**S16 Planning Application for
Proposed Composite Redevelopment with Residential, Commercial and Trade Mart,
Social Welfare Facilities and School uses and Minor Relaxation of Building Height Restriction
at New Kowloon Inland Lot No. 6032, 1 Trademart Drive, Kowloon Bay, Kowloon**

(S16 Planning Application No. A/K22/37)

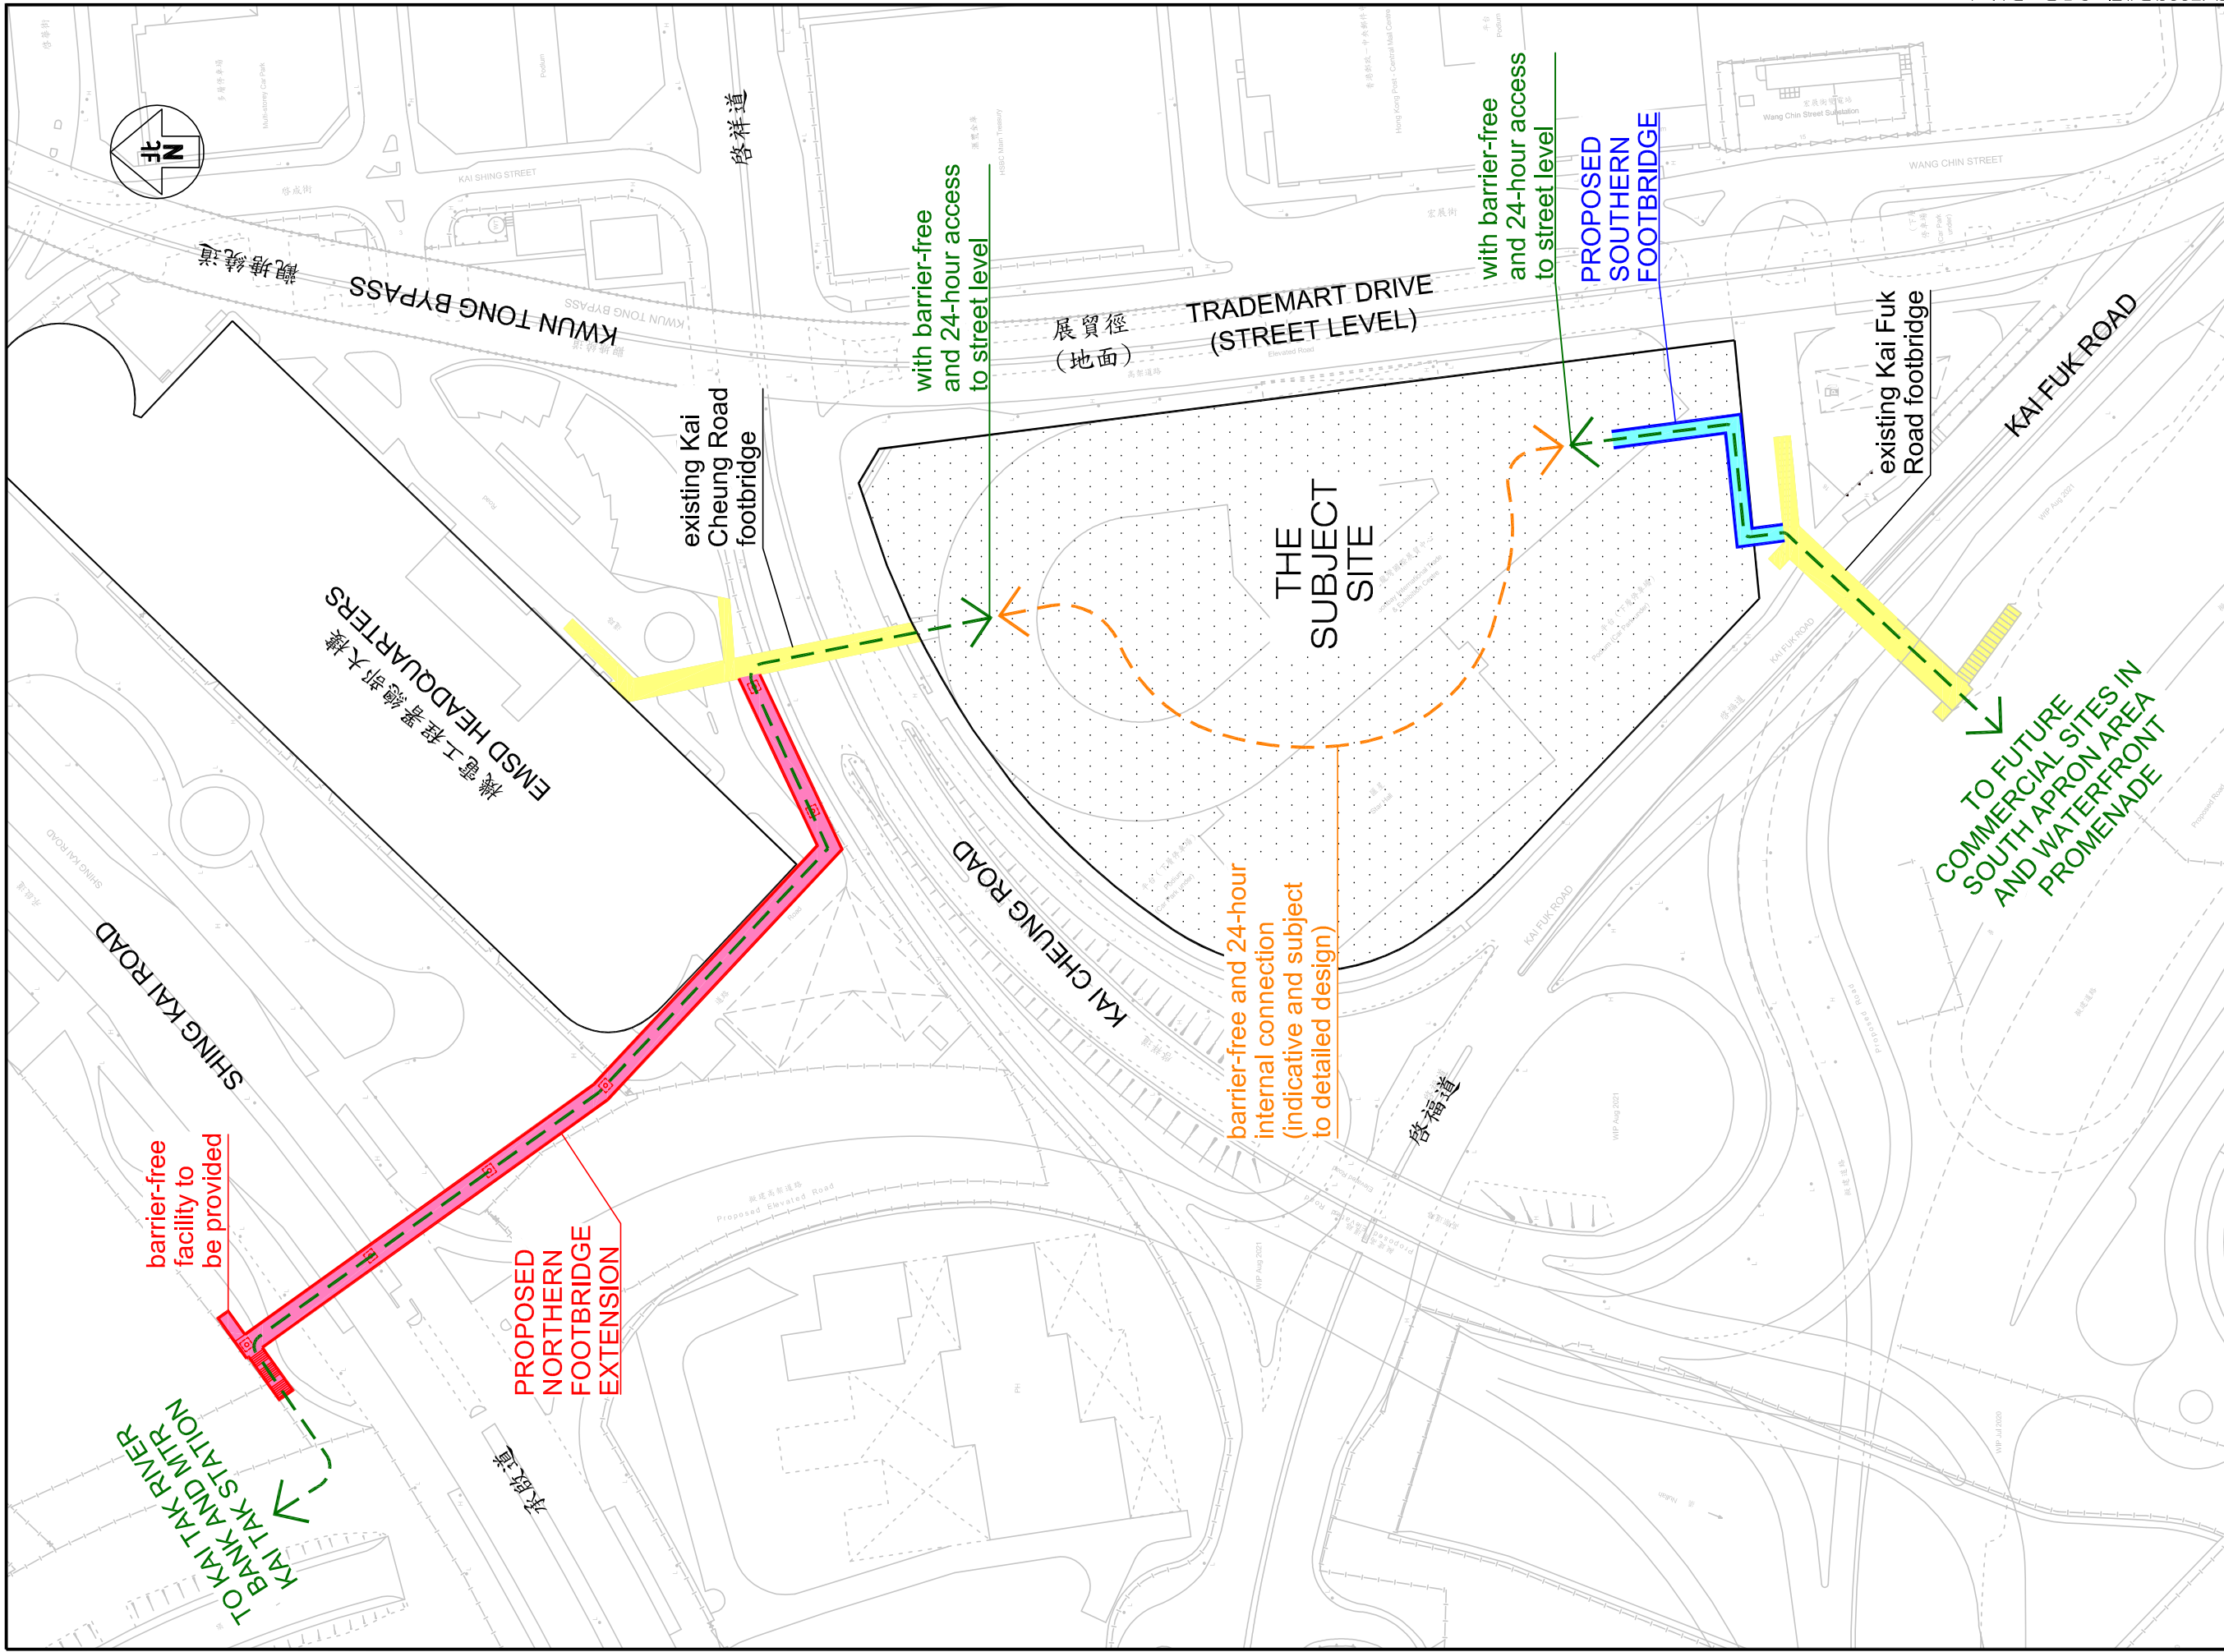
1.19	<p>Figure 3.4 Please advise if the loading/unloading bays would intrude into the EVA at the first floor. Please seek comments from FSD and BD if such arrangement fulfils the relevant buildings and fire safety ordinance requirements. Please use color or hatched marking to highlight the area of EVA.</p> <p>Also, please advise the purpose of cul-de-sac at southern side of the first floor, near to the ramp to G/F. Please provide the swept path analyses for demonstration its feasibility.</p>	<p>The loading / unloading bays and lay-bys on 1/F will not encroach into the EVA demarcated in red colour. Comments and agreement from relevant government departments will be sought during the detailed design stage.</p> <p>The turn-around area outside Tower 1 has been changed to be hammerhead and is suitable for a 12m fire appliance to conduct a 3-point turn.</p>

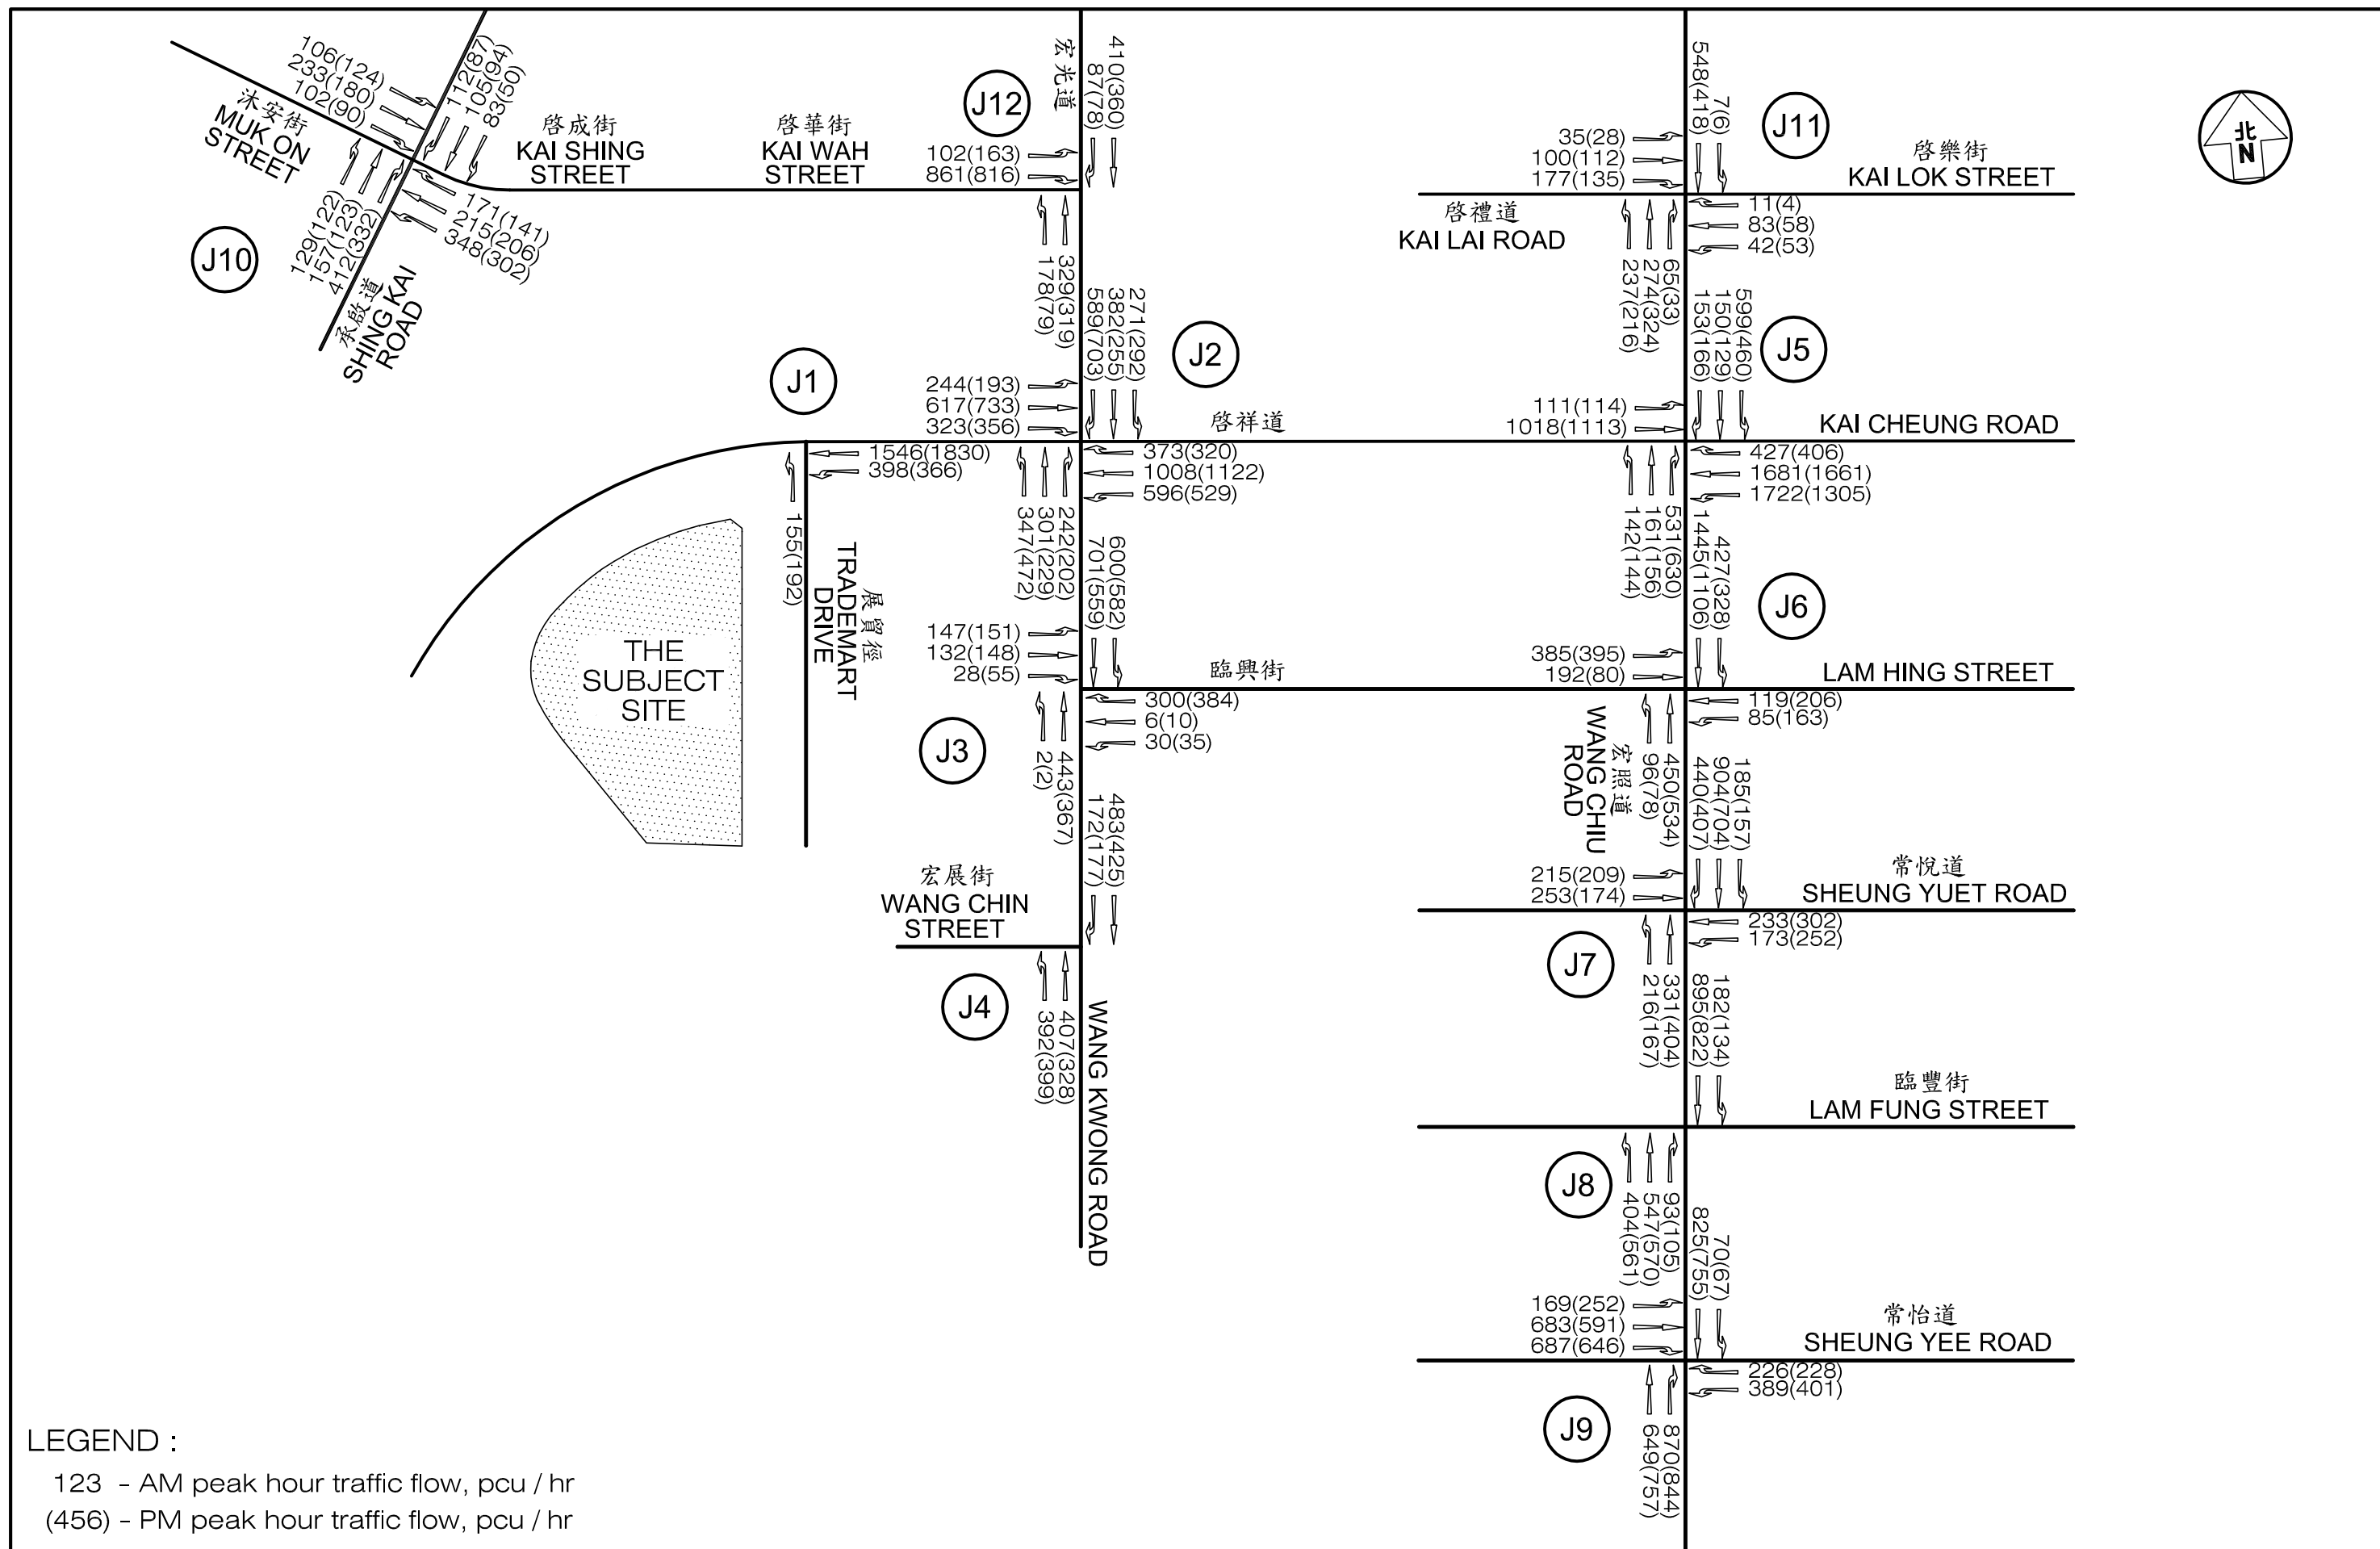
1.20	<p>Figure 3.5 Please advise if there is any direct connection between the proposed Southern Footbridge and the existing KITEC-EMSD footbridge (also the proposed Northern Footbridge Extension) within the proposed redevelopment, which is barrier-free, 24-hour access and free-of charge.</p>	<p>A 24-hour pedestrian circulation with barrier free within the proposed development between the northern footbridge (to the existing EMSD Headquarters) and the proposed southern link bridge towards Kai Fuk Road will be provided for a pedestrian seamless connection. Public can access the internal linkage free of charge.</p>
